**CONTRACT NO: FACD08 RESTROOMS AT PREBLE TRUCK PARKING
PROJECT: DOT-250005**

ADDENDUM NUMBER TWO (2)

FACD08 Restrooms at Preble Truck Parking
Ohio Department of Transportation (ODOT)
I-70 WB @ MM 01, New Paris, Ohio 45347
Preble County

SHEET
S0.3

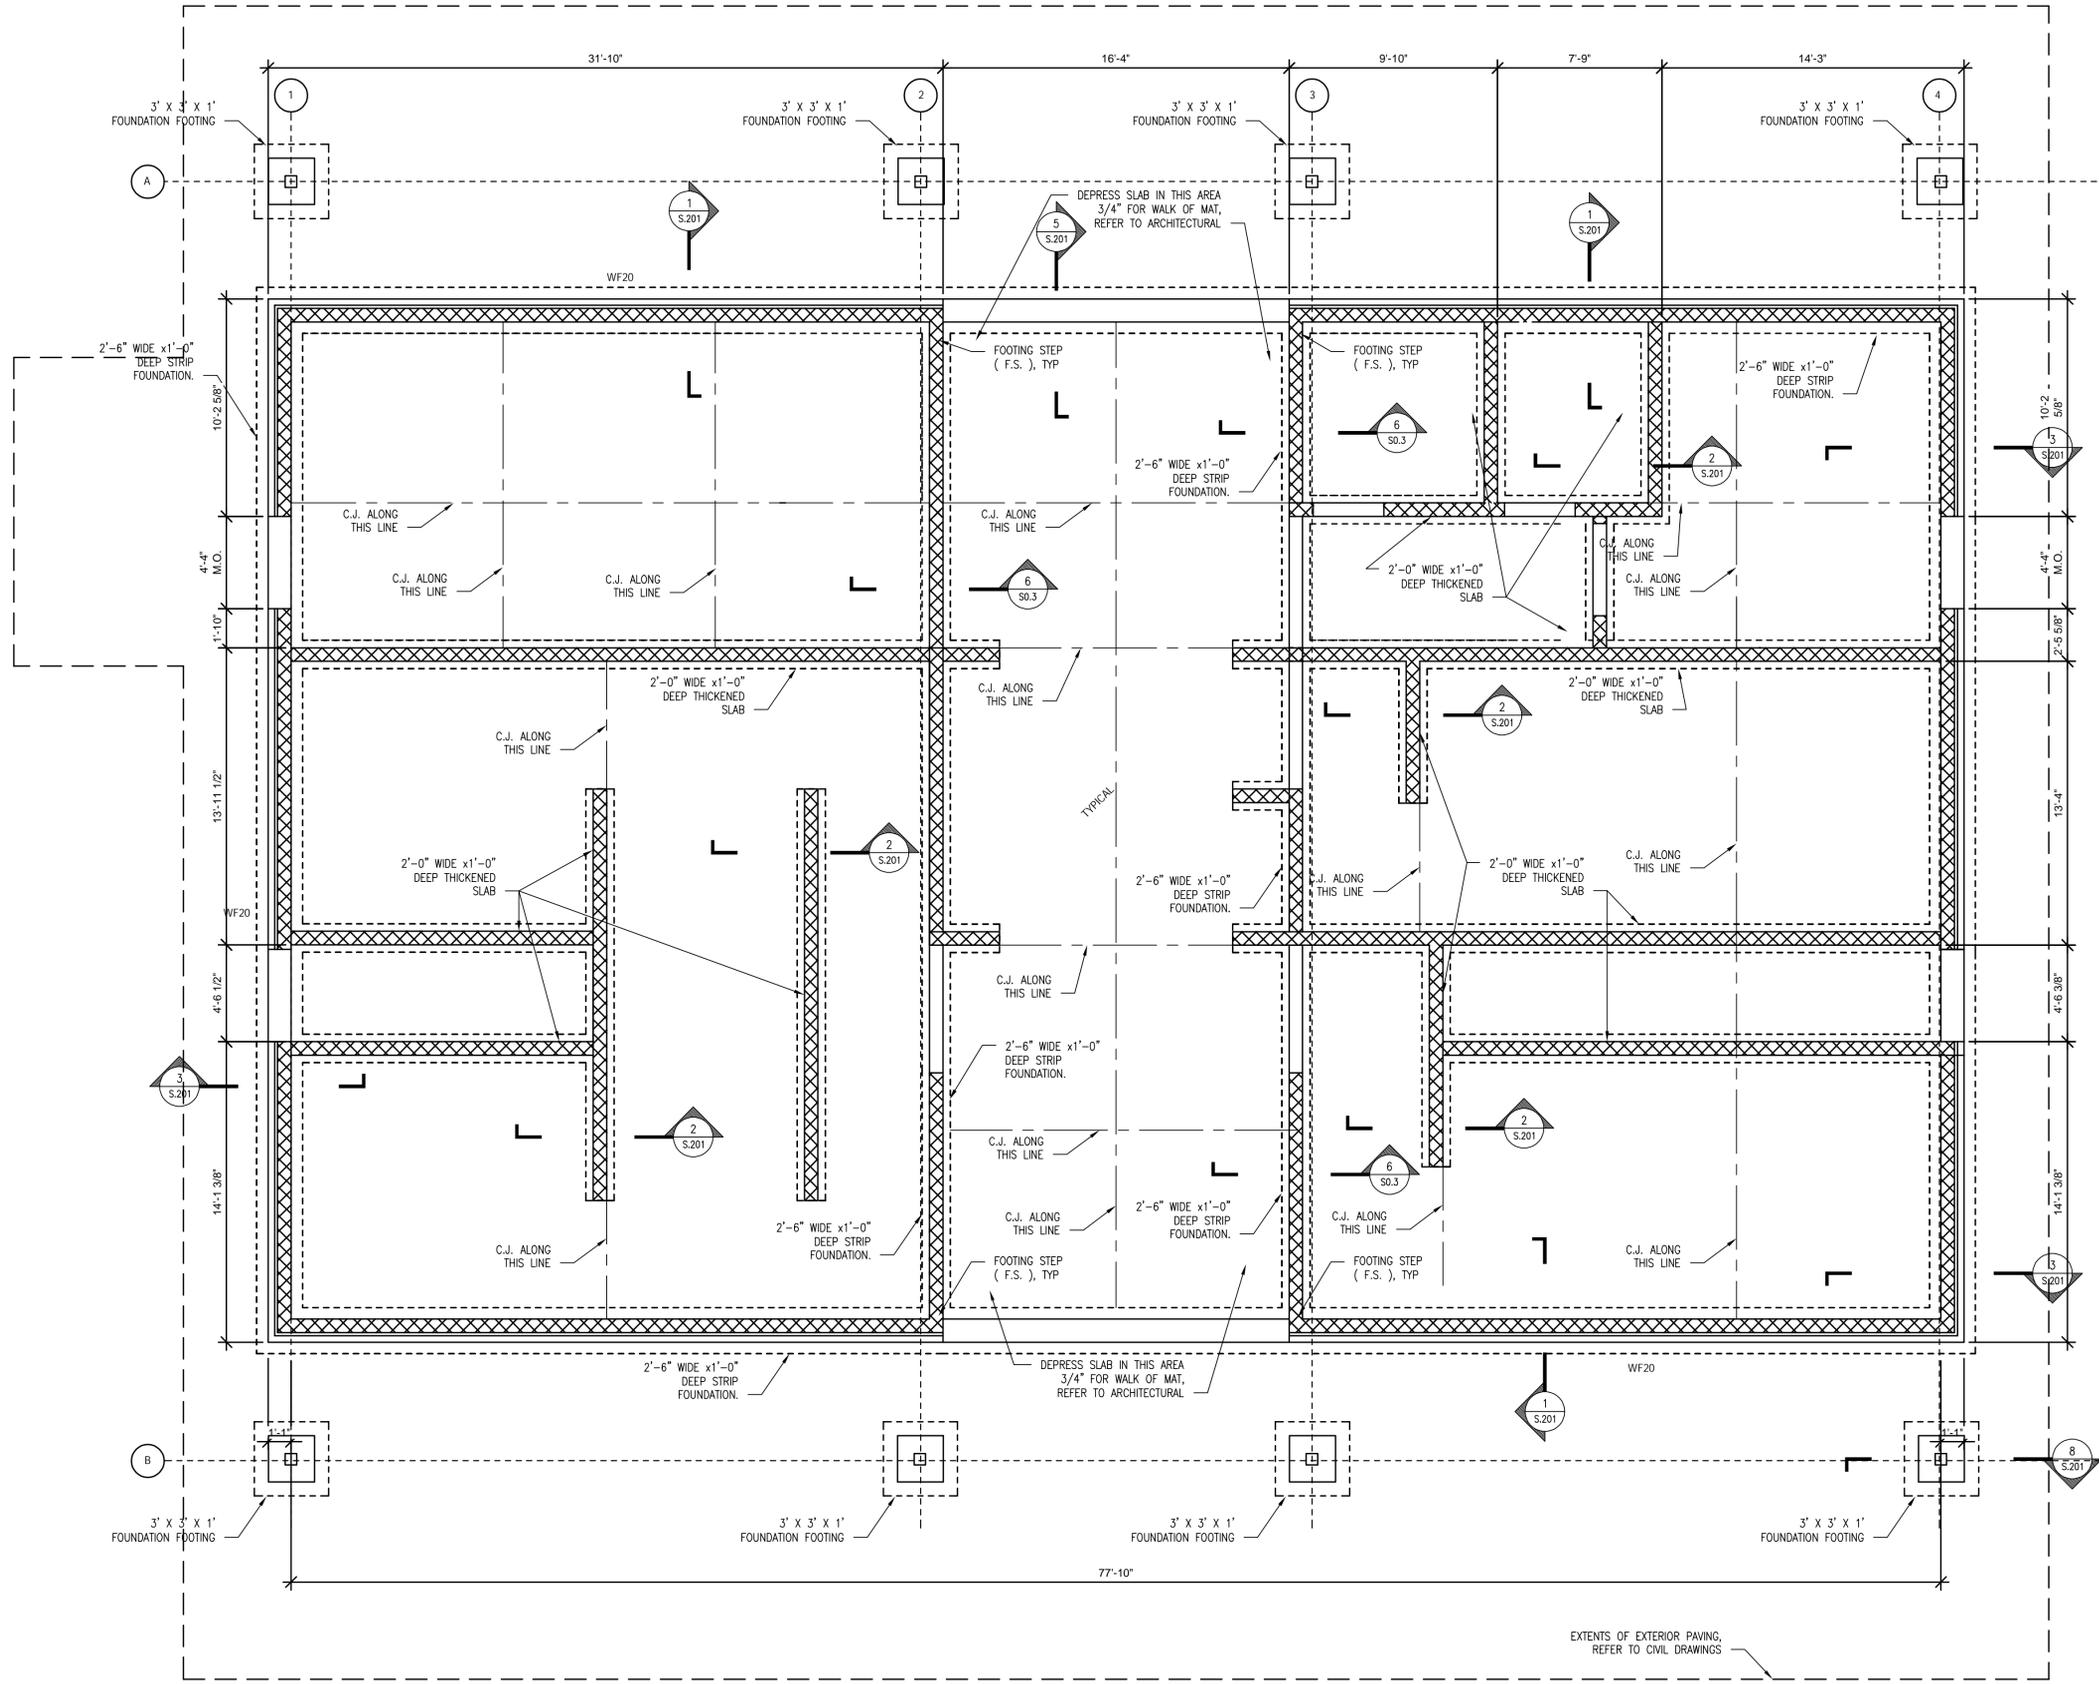
RFI-18: : The wall along column line 3 is called out as a 2'6" x 1'0" strip foundation. However, detail 2/S201 is shown at the same wall, indicating a thickened slab. Please clarify. See below:

Response: The wall along column line 3 shall have a 2'-6" X 1'-0" strip foundation. S101 has been revised to show proper details.

SHEET
P.101

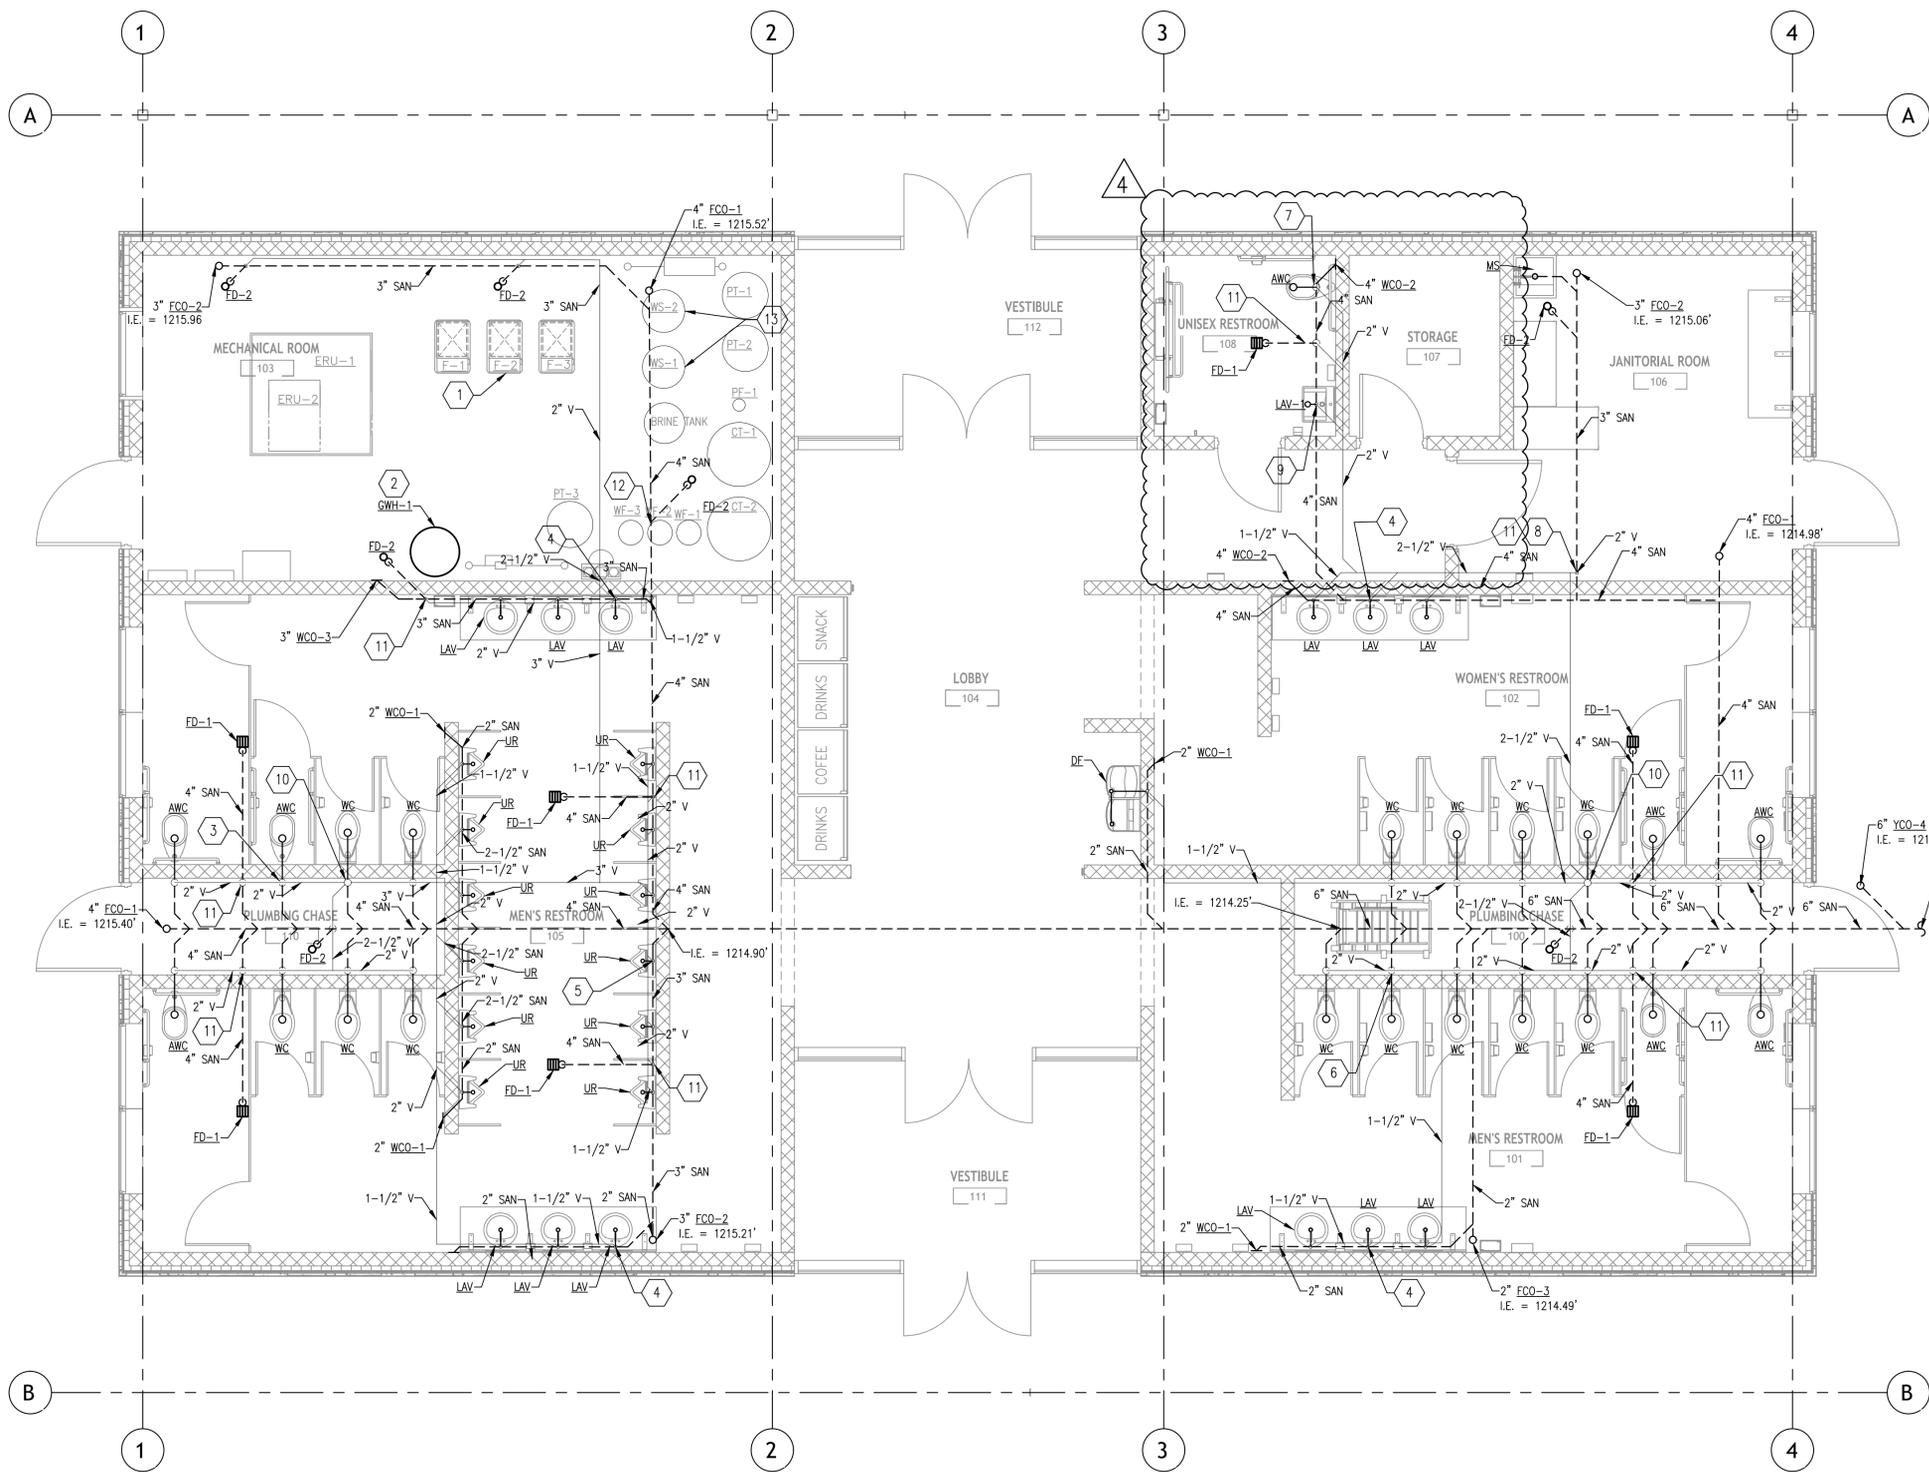
RFI-8: There is a specification for wall mounted access doors but no specific locations shown on drawings. Plumbing Fixture Schedule on A.400 calls out access panels of different sizes for each plumbing fixture. Is an access panel needed at every plumbing fixture on the drawings? Additionally, all of these plumbing fixtures are located in CMU walls and there are large plumbing chases in the building, are access panels needed at all? Please Advise.

RFI-29: Are we to assume that each urinal is going to have an access panel behind it? The fixture is called out with a back spud but there is not a chase for the flush valves behind the urinals. You have to have access to this style of flush valve. (This would put 4 access panels within restroom stalls)

Response: Please see coded note 7 on a.400 for fixtures that will receive access panels. Also updated the sheet notes and coded notes on Sheet P.101 & P.102 to give clarification.

Response: All flush valves for urinals will be installed within the wall and each of these will have its own access panel, also for the AWC & LAV-1 in family restroom will have access panels. Updated the sheet notes and coded notes on Sheet P.101 & P.102 to give clarification.
